To: X3T10 Membership X3T10/96-129r0

From: Wally Bridgewater Subject: Voltage Driven Outputs

Date: 1/96

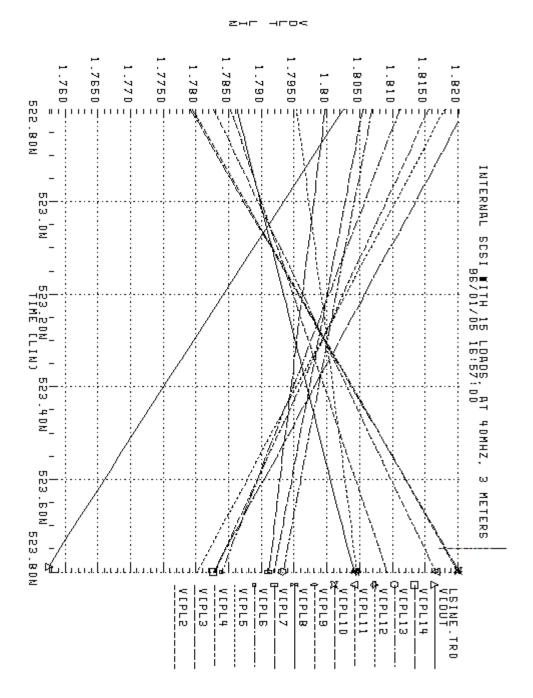
Need slew rate control if output is directly connected to output. Should use series termination resistor, maybe \sim 30 ohms. Figure 2.

This means only real difference between current mode and voltage mode outputs, is where the resistors go, source or drain. Figures 2 & 3.

For spice circuit simulations, couldn't see much difference between figure 2 (voltage mode) or figure 3 (current mode), but simulations didn't work either way.
